# CITY OF ALBUQUERQUE

**RE: Wintergreen Apartments  
10800 Golf Course Rd NW  
Grading & Drainage Plan and Drainage Report  
Engineer's Stamp Date: 06/08/21  
Hydrology File: A12D008D**

Based upon the information provided in your submittal received 06/10/2021, the Grading & Drainage Plan and Drainage Report **are not** approved for Building Permit. The following comments need to be addressed for approval of the above referenced project:

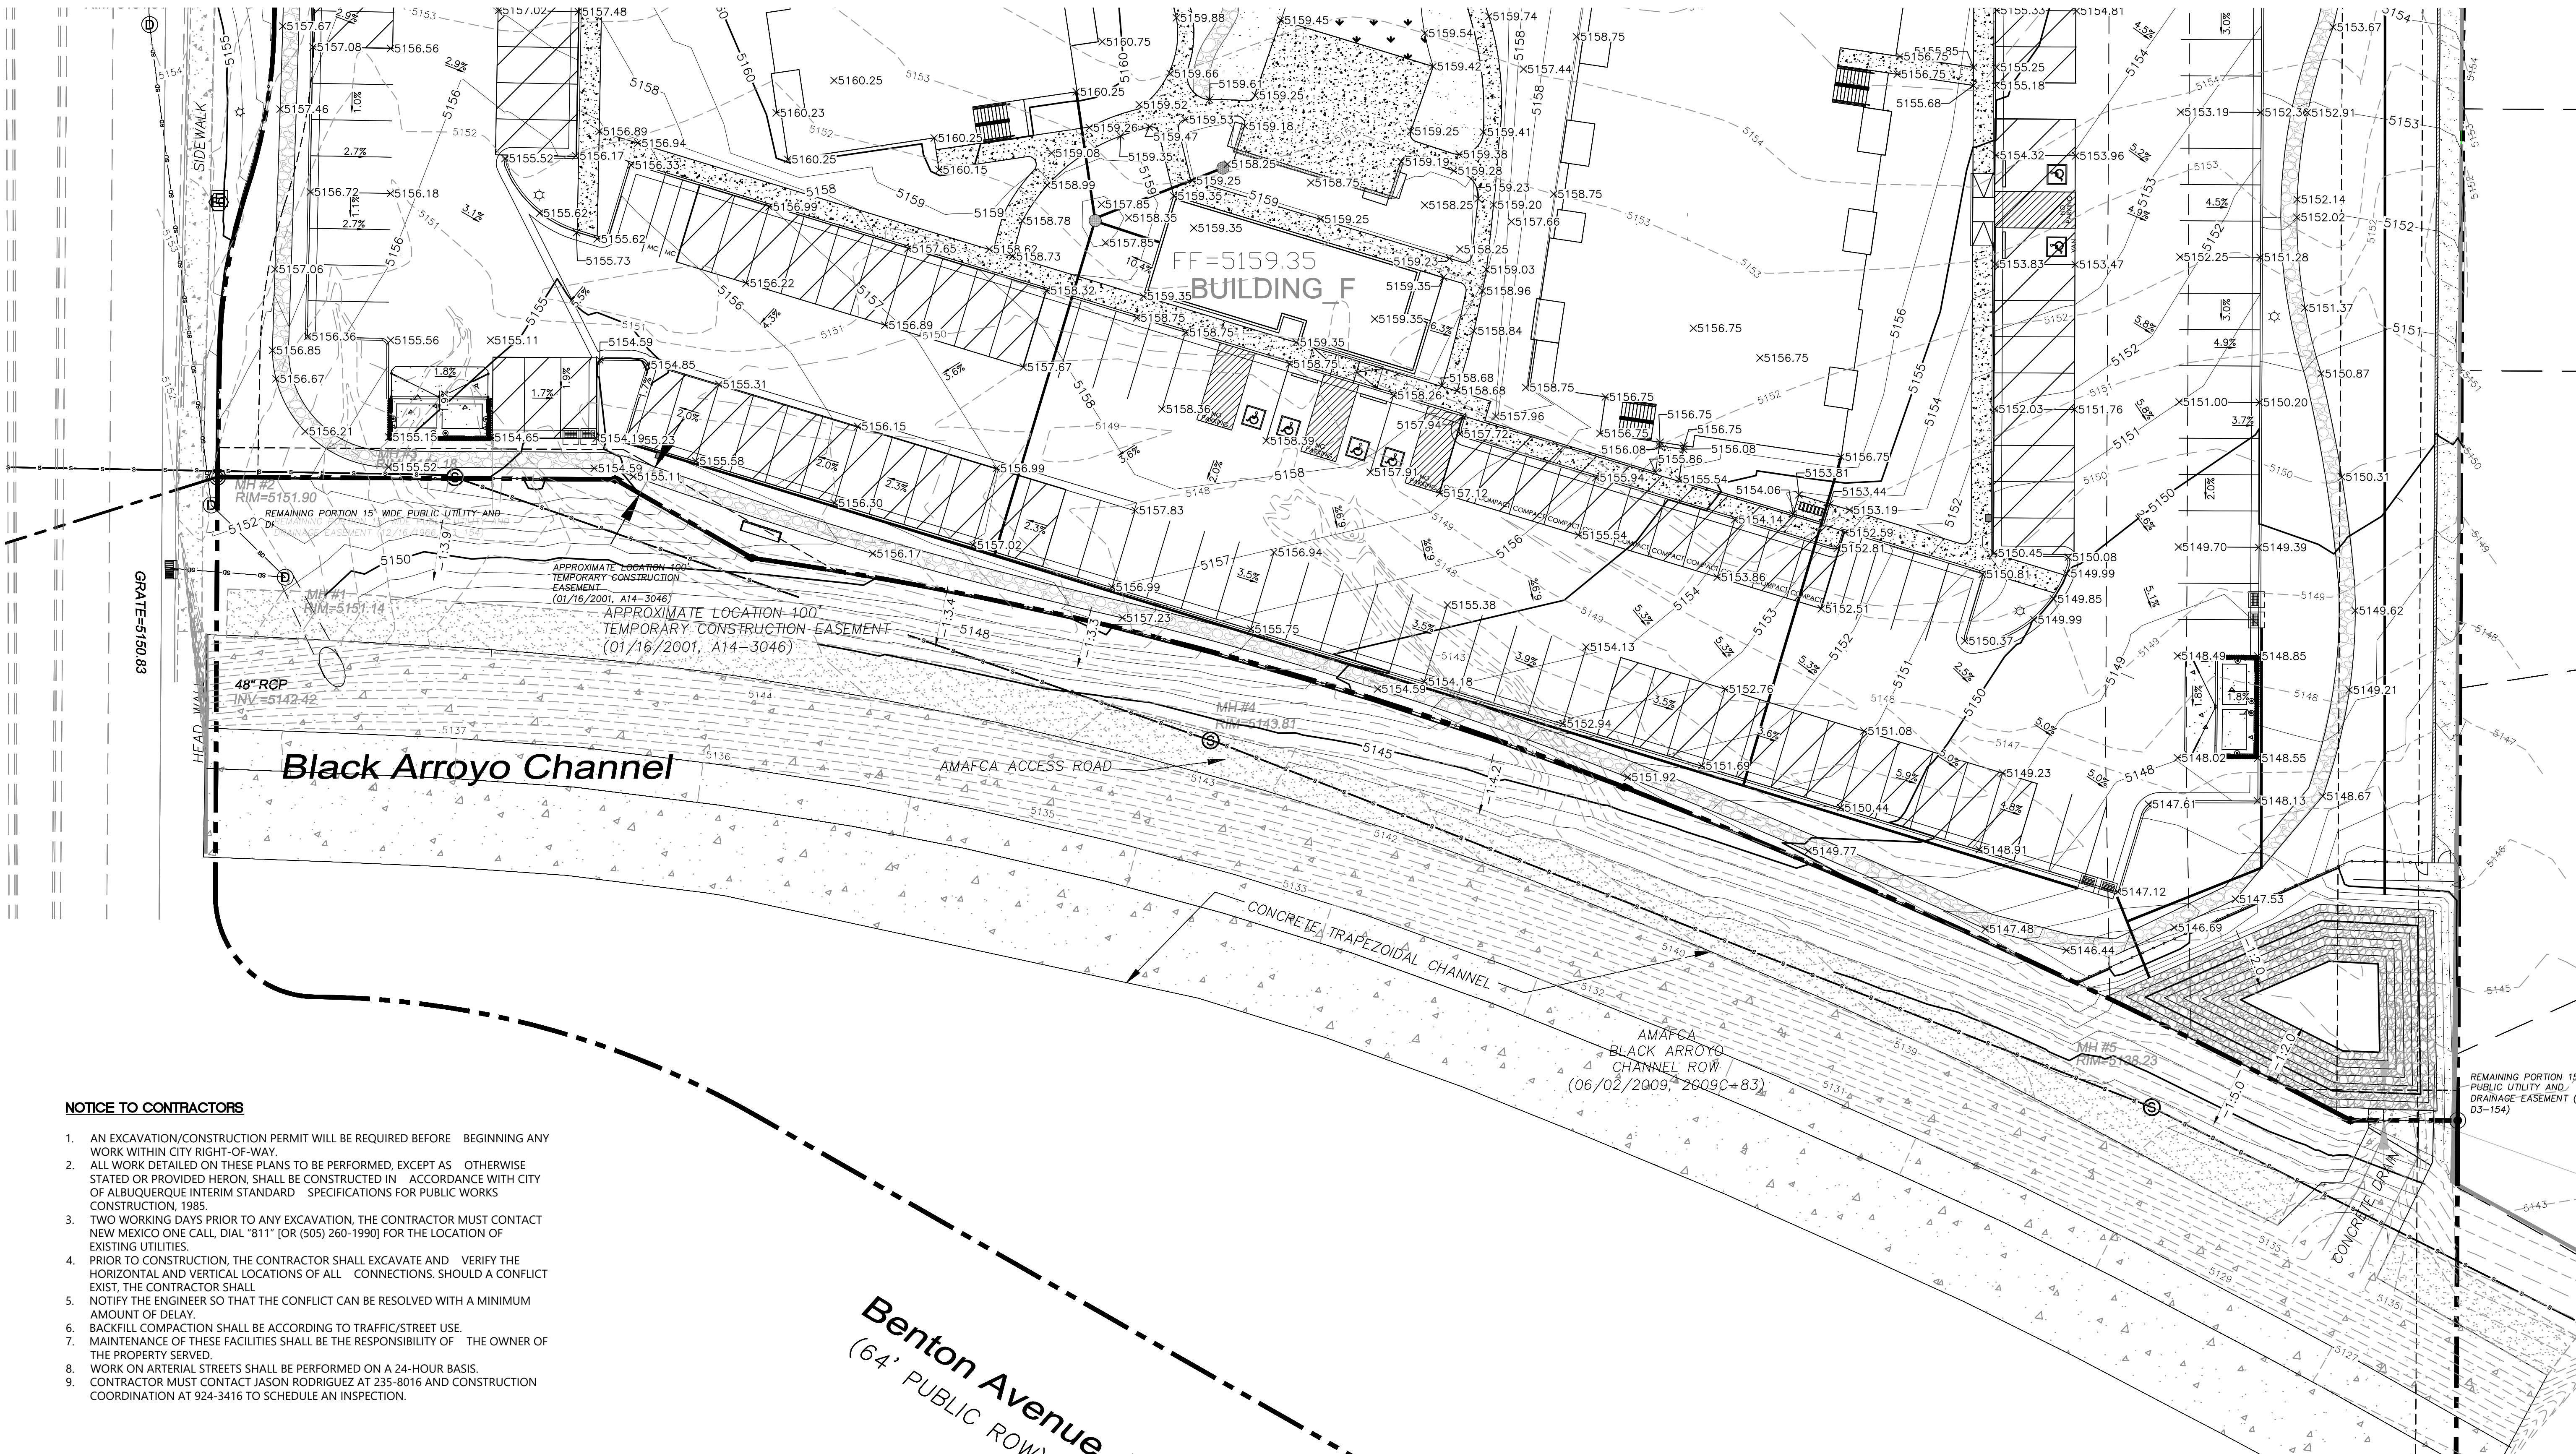
3. Sheet C3-C5. Please either add a note, "all spot elevations next to curbs is flowline elevation" or add "FL" behind those spot elevations that are next to the curbs.

"ISSUED FOR PERMIT - NOT FOR CONSTRUCTION"		
ENGINEER'S SEAL	WINTERGREEN LUXURY APARTMENTS 10820 GOLF COURSE RD. NW	DRAWN BY BF
 06/08/21	SOUTH GRADING PLAN	DATE 5/19/2021
		2020013_GRB_DETAIL
RONALD R. BOHANNAN P.E. #7868		SHEET # <b>C5</b>
		JOB # 2020013

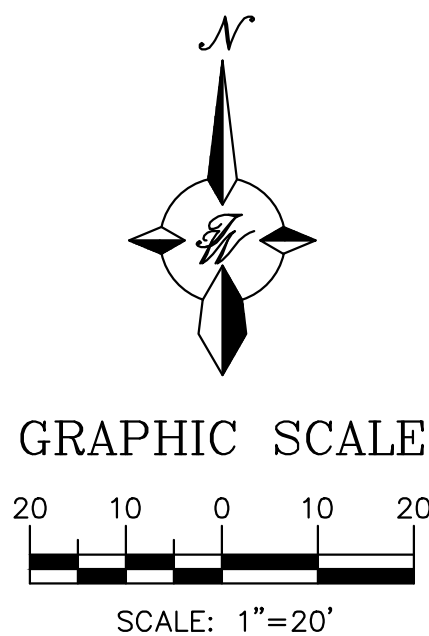
4. Sheet C5. Per our phone conversation on July 6, 2021, AMACA is requiring the removal and replacement of the existing concrete channel at the southeast corner of the site. Please show all elevations need to construct this. This information may be shown as a blowup area on Sheet C7 next to the cross-section detail of the channel.

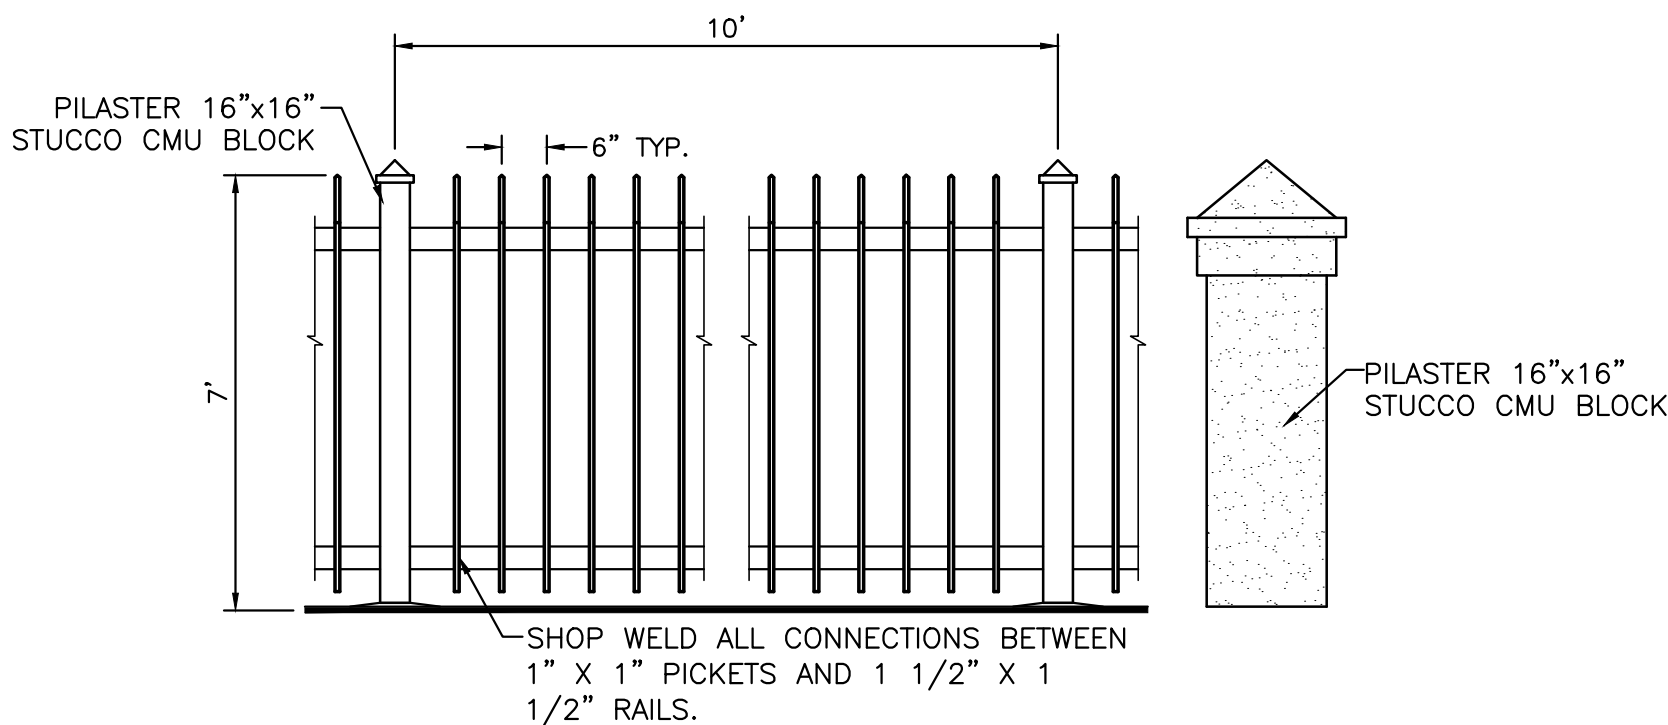
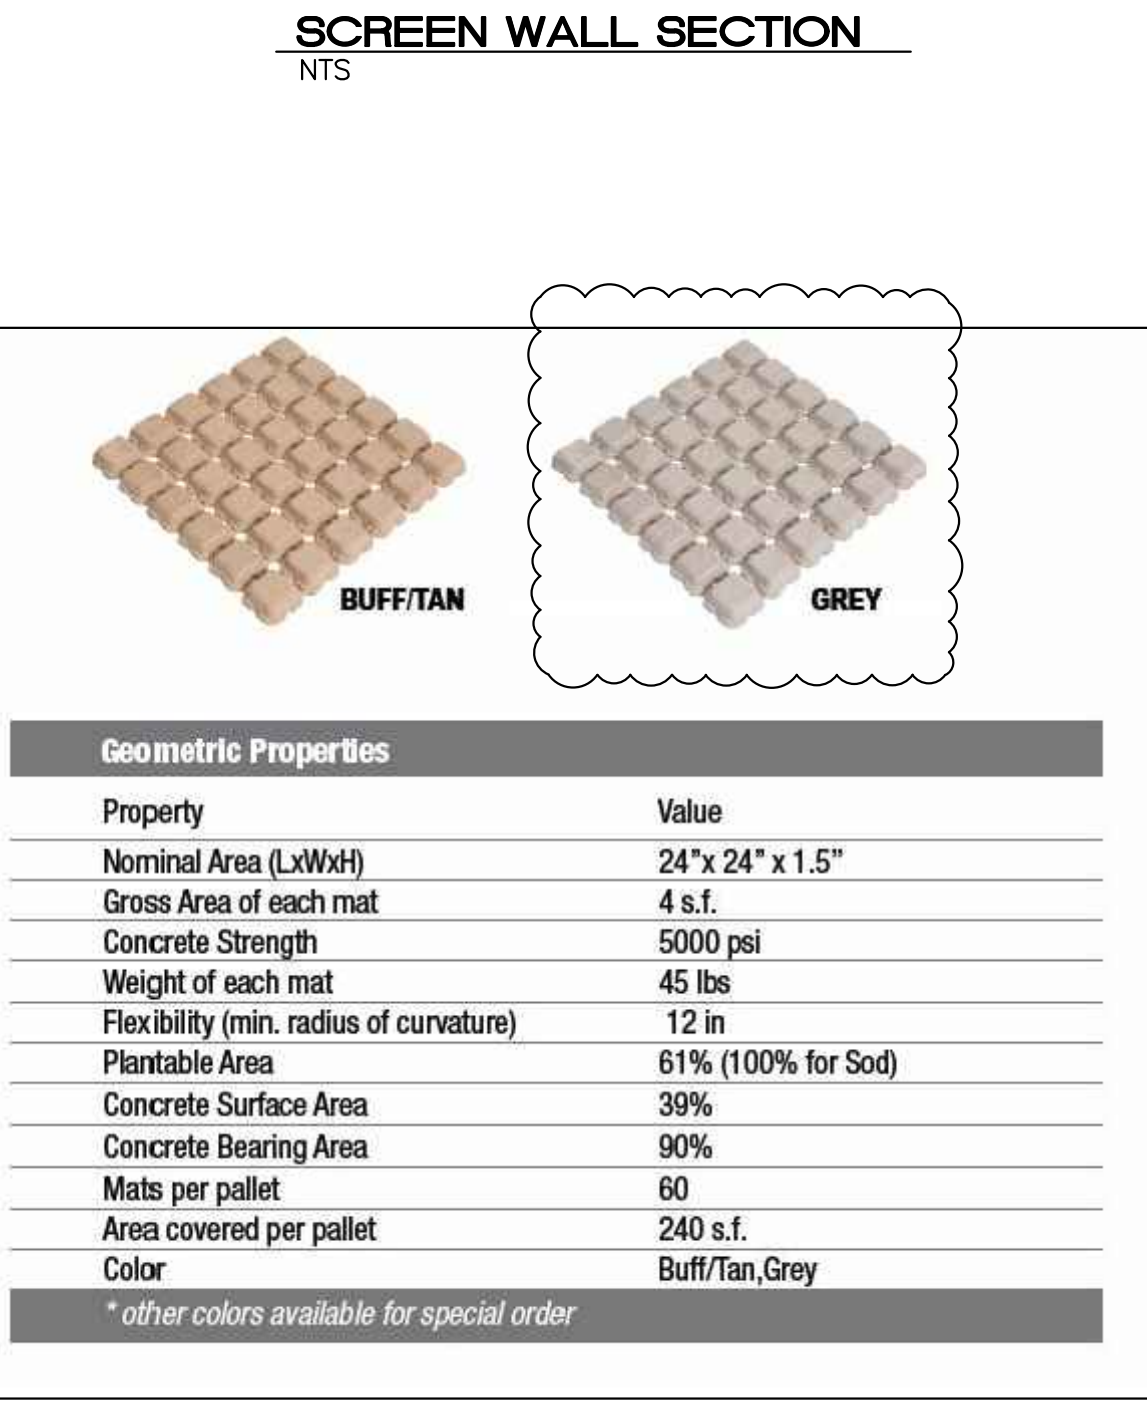
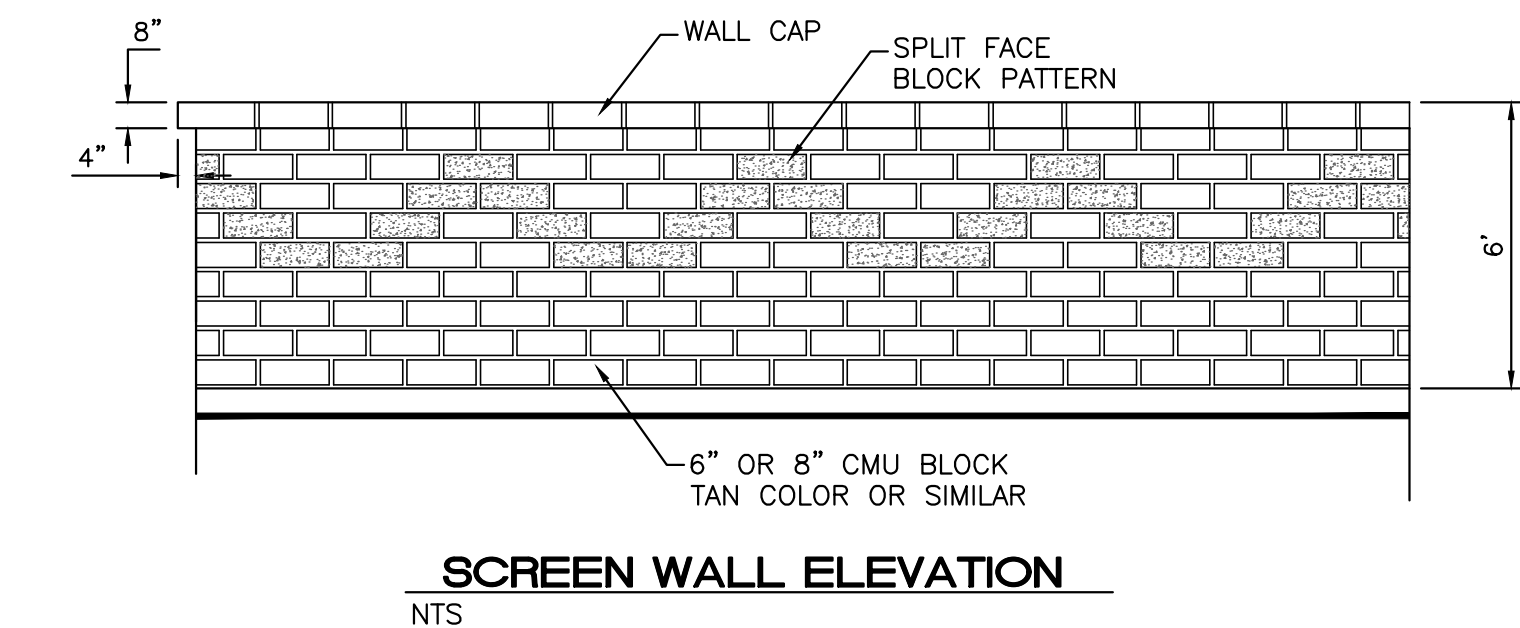
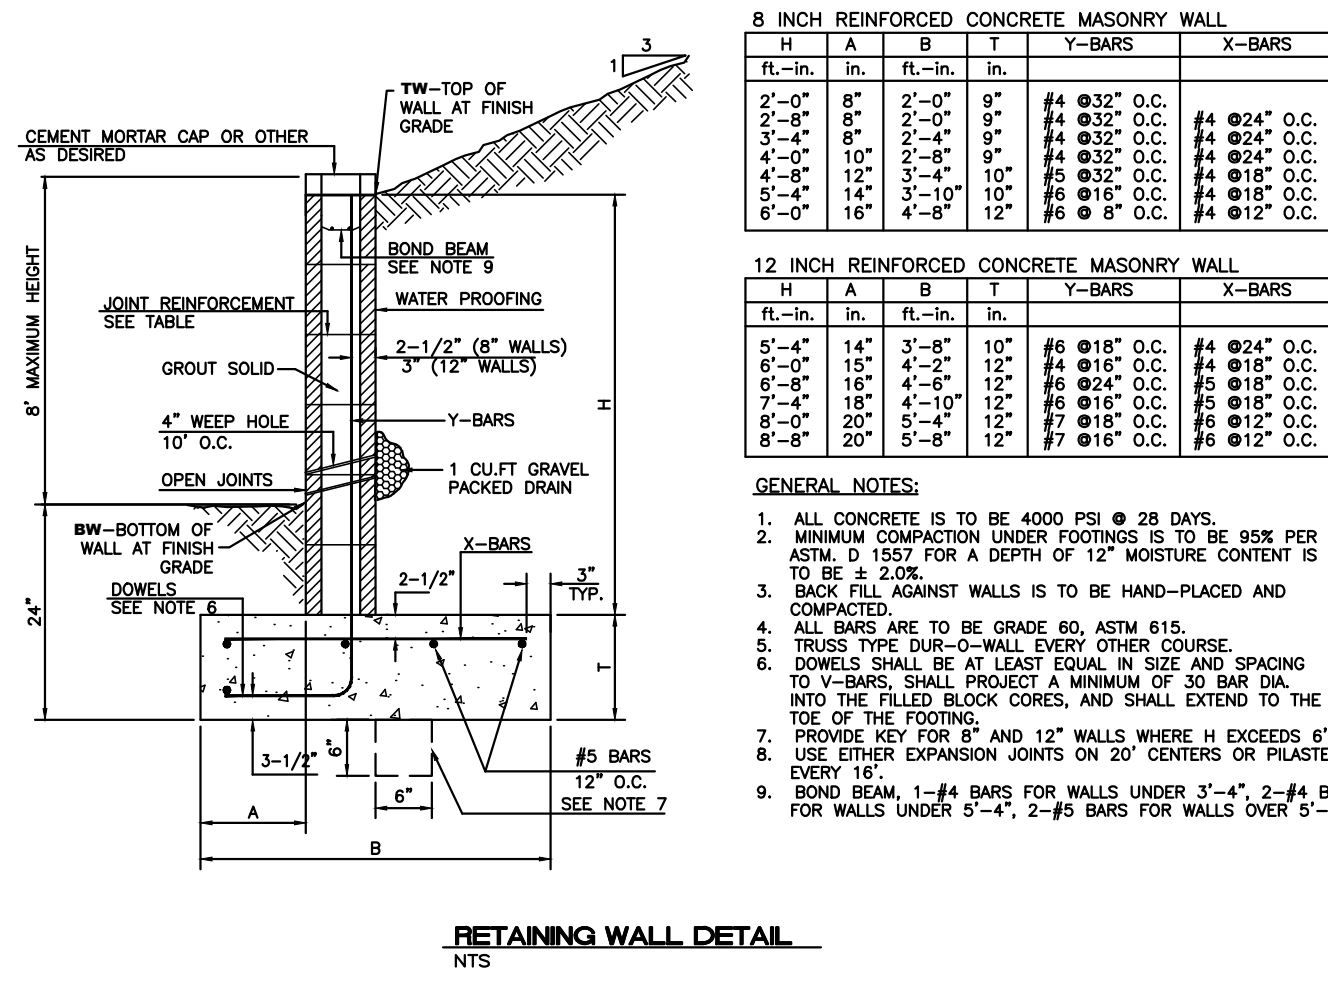
5. Sheet C7. The Vehicle Gate Detail and Carport Detail are from another project. The Carport Detail has a structural engineer's stamp and date on it. Therefore, these details were payed under that project and the company and engineer needs to provide updated details for this project. Please check with the architect about this since these are not standard details.
